Addendum No. 1 to JESD209A - Low Power Double Data Rate (LPDDR) SDRAM, 1.2 V I/O

JESD209A-1

(Addendum No. 1 to JESD209A, February 2009)

ADDENDUM NO. 1 TO JESD209A
LOW POWER DOUBLE DATA RATE (LPDDR) SDRAM, 1.2 V I/O

Figure 1 — Extended Mode Register Definition

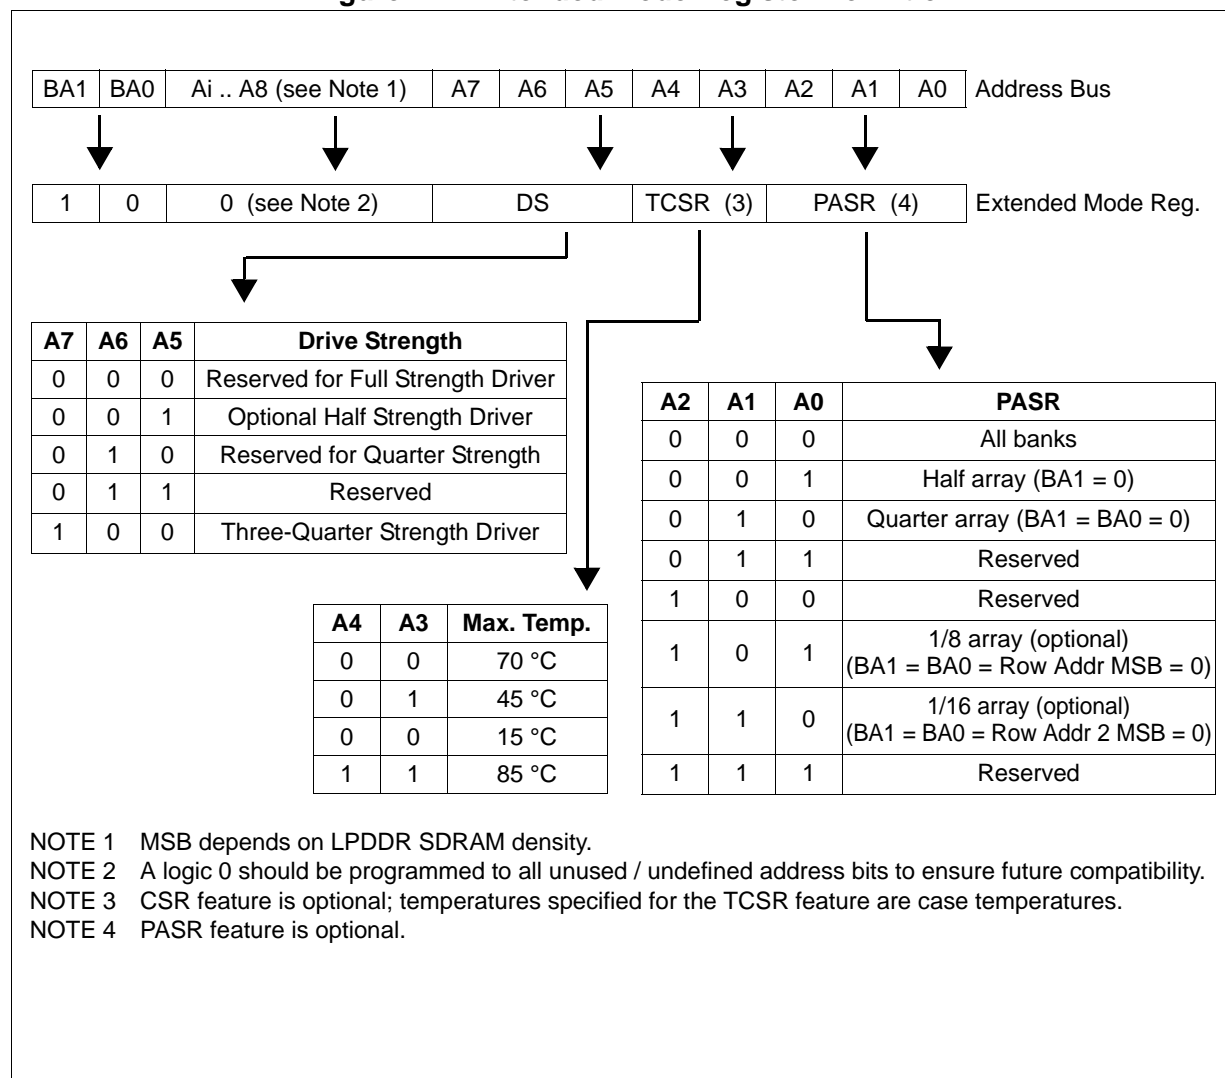
This Extended Mode Register definition for 1.2 V I/O replaces the Extended Mode Register in JESD209A when 1.2 V I/O operation is required.

Address bits A0-A2 specify PASR, A3-A4 the TCSR, A5-A7 the Drive Strength. A logic 0 should be programmed to all the undefined addresses bits to ensure future compatibility. Reserved states should not be used, as unknown operation or incompatibility with future versions may result.

The drive strength may be set to half (optional) or three-quarter strength via address bits A5, A6, and A7. The I-V curves for half drive strength (optional) and three quarter-strength drivers for 1.2 V I/O are included in this document, see [Figure 2](#) and [Figure 3](#).

Figure 2 — I-V Curves for Three-Quarter Drive Strength

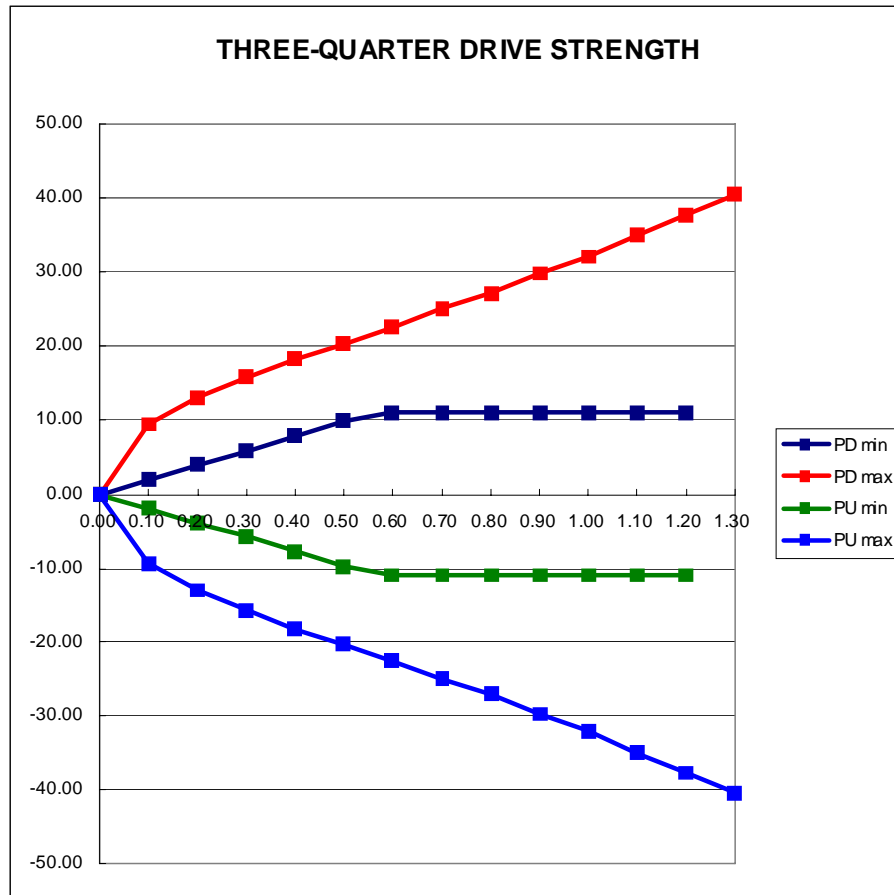
LPDDR SDRAM output driver characteristics are defined for three-quarter drive strength and optional half drive strength operation as selected in the Extended Mode Register. Table 2 shows the data in a tabular format suitable for input into simulation tools. Figure 2 and Figure 3 show the driver strength characteristics graphically.
